Title of Change:	PQFN_33CLP Large Die Device Metal Clip + Gate Wire Conversion Qualification.
Proposed First Ship date:	23 Mar 2023 or earlier if approved by customer
Contact Information:	Contact your local onsemi Sales Office or Joseph.Mendoza@onsemi.com
PCN Samples Contact:	Contact your local onsemi Sales Office. Sample requests are to be submitted no later than 30 days from the date of first notification, Initial PCN or Final PCN, for this change. Samples delivery timing will be subject to request date, sample quantity and special customer packing/label requirements.
Additional Reliability Data:	Contact your local onsemi Sales Office or Aileen.Allado@onsemi.com
Type of Notification:	This is a Final Product/Process Change Notification (FPCN) sent to customers. FPCNs are issued 90 days prior to implementation of the change. onsemi will consider this change accepted, unless an inquiry is made in writing within 30 days of delivery of this notice. To do so, contact PCN.Support@onsemi.com

Final Product/Process Change Notification

Document #: FPCN23091X

Issue Date: 08 Dec 2022

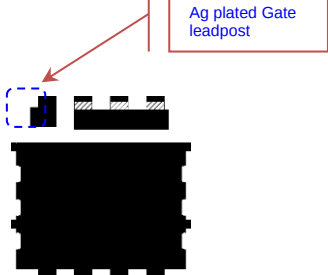
- Change of Clip from Saw Singulated Pre-molded Clip to Punch Singulated Metal Clip, and addition of Wirebond process for Gate wire.
- Removal of exposed tie bars at bottom part of package and change in overall package thickness from 0.90-1.05mm to 0.75-0.85mm

Material to be changed	Before Change Description	After Change Description
Clipframe	Pre-molded Clip (0.254mm thick) 	Bare Metal Clip (0.127mm thick) with 2mil Pd coated Cu (PCC) Gate Wire 
Leadframe	Leadframe without plating on Gate leadpost Die Attach Pad Dimensions: 2.667x2.032mm Source Leadpost Pad Dimensions: 1.62x0.47mm Gate Leadpost Pad Dimensions: 0.58x0.47mm	Leadframe with Spot Ag plating on Gate leadpost for Cu wire bonding purposes Die Attach Pad Dimensions: 2.898x2.261mm Source Leadpost Pad Dimensions: 1.705x0.35mm

Top View	Gate Leadpost Pad Dimensions: 0.46x0.35mm  Top View
Package Case Outline	Presence of exposed tie bars at bottom part of package. Case 483AK with Dim A (Package thickness) at 0.90-1.05mm  Bottom View (Package Outline)	No exposed tie bars at bottom part of package. Case 483AW with Dim A (Package thickness) at 0.75-0.85mm  Bottom View (Package Outline)
